Access Compliance Report Public Rights-of-Way (Curb Ramps)

Main Street: RANUNCULUS_ST		Cross Street: LANGFORD_RD		Location:	S
ADA ID: RPRK211111115130	Ramp Type: Type 4 - Parallel	Initial Pass/Fail: Fail	Overall Compliance: No	Severity Score:	30
Codes/Mitigation Info/Possible Solution			Field Measurements/Component Compliance

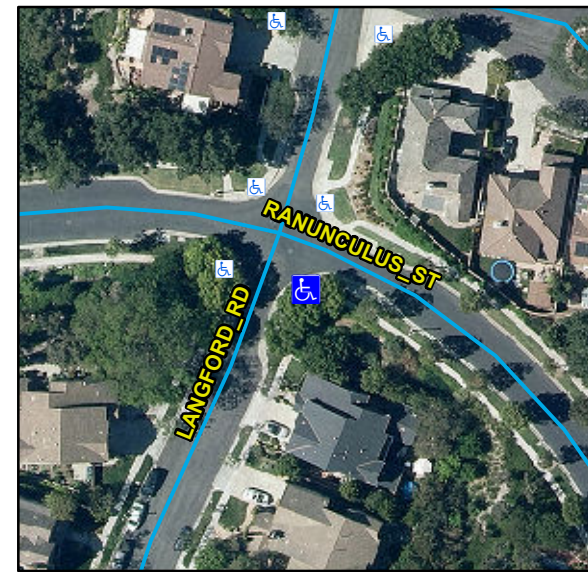
Compliance	Description	Data	Compliance	Description	Data
N/A	Ramp Length LT (in)	136	N/A	Ramp Length RT (in)	139
Yes	Ramp Width LT (in)	53	Yes	Ramp Width RT (in)	53
No	Ramp Run Slope LT (%)	14.9	Yes	Ramp Run Slope RT (%)	2.1
Yes	Ramp Cross Slope LT (%)	1.4	Yes	Ramp Cross Slope RT (%)	1.3
N/A	Landing Present	N/A	N/A	DWS Provided	N/A
N/A	Landing Length (in)	N/A	N/A	DWS Contrast	N/A
N/A	Landing Width (in)	N/A	N/A	DWS Length (in)	N/A
N/A	Landing Run Slope (%)	N/A	N/A	DWS Full Width	N/A
N/A	Landing Cross Slope (%)	N/A		DWS Offset Type	N/A
N/A	Landing Movement Obstructed?	N/A	N/A	DWS Offset Left (in)	N/A
	Landing Movement Type	N/A	N/A	DWS Offset Right (in)	N/A
N/A	Landing Shared	N/A			
N/A	Clear Space	Yes			
N/A	Clear Space To Crosswalk (in)	N/A			
N/A	Marked Crosswalk 1	No	N/A	Marked Crosswalk 2	No
	Crossing 1 Direction	NE		Crossing 2 Direction	NW
	Marked Crosswalk 1 Width (in)	N/A		Marked Crosswalk 2 Width (in)	N/A

Remove & Replace Curb Ramp With Two New Directional Ramps or Equivalent.
